FCO CA10122
Mechanical Film Guide Mount Upgrade Procedure

1. BACKGROUND

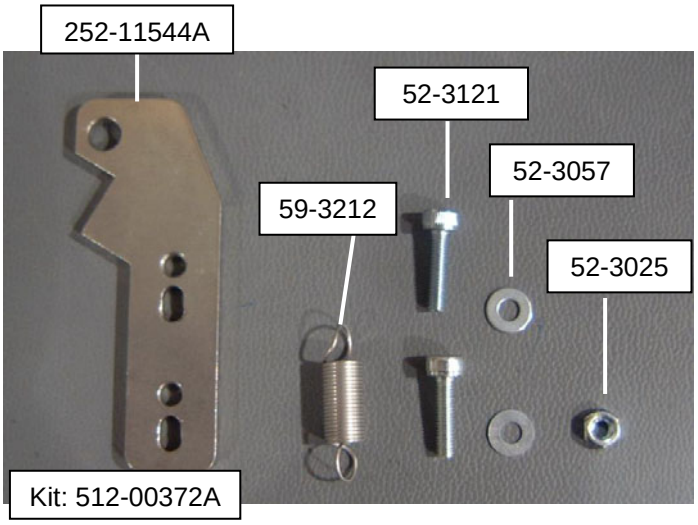
On MCE *Trendsetter* output devices with the drum drive V-belt (serial numbers TM1018 and higher), the mechanical film guide mount on the away side rests on the belt when it engages. If this issue is not addressed, it will cause reliability problems in the long run.

Install the mechanical film guide upgrade kit (part number 512-00372A).

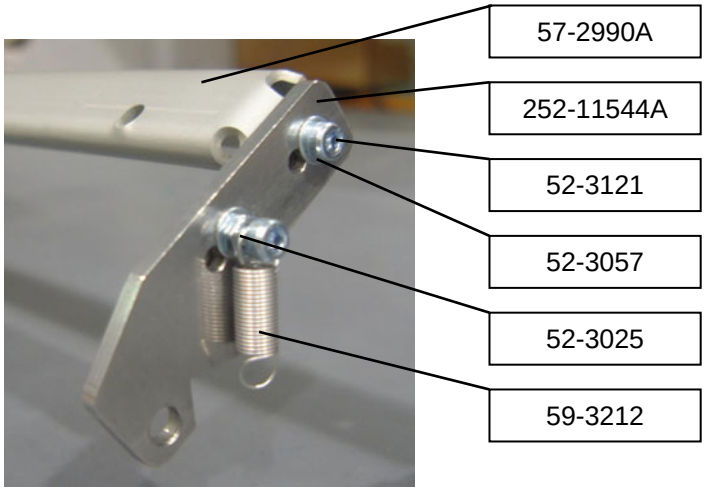
4. Replace the away-side assembly with the parts in the field upgrade kit.

Part Number	Part Name		Quantity
512-00372A	Kit, mechanical film guide upgrade. Kit contains:		1
	52-3121	Screw, M3 x 12, socket-cap, steel-plated	2
	52-3057	Washer, M3, flat, steel-plated	2
	52-3025	Nut, M3, steel-plated	1
	59-3212	Spring, extension, 0.24" x 0.88" x 0.022", stainless steel	1
	252-11544A	Guide mount, LEC, away	1

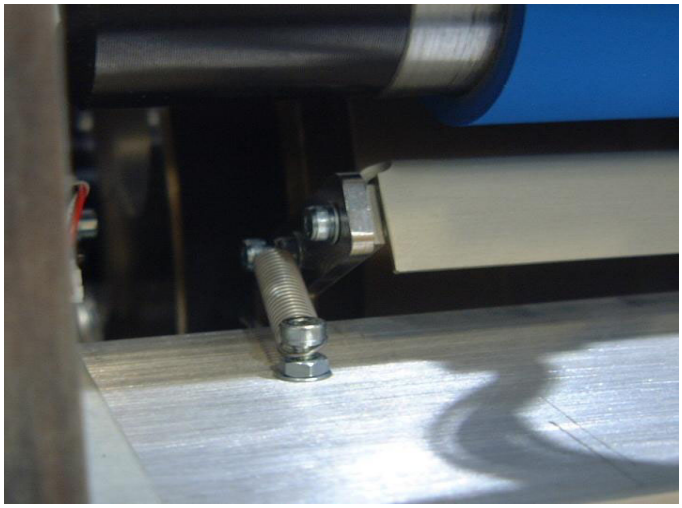
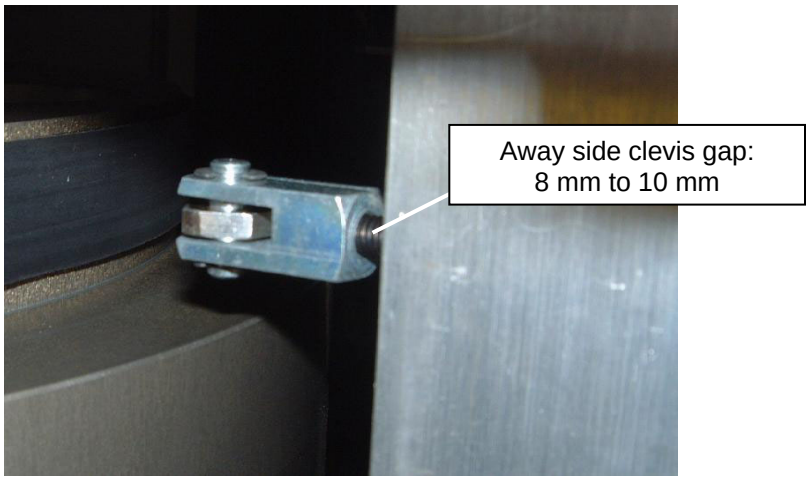
5. Reinstall the upgraded film guide assembly.

Note: The away-side clevis needs to have a gap of between 8 mm to 10 mm. The home-side clevis should not be touched (its gap is between 4 to 6 mm).
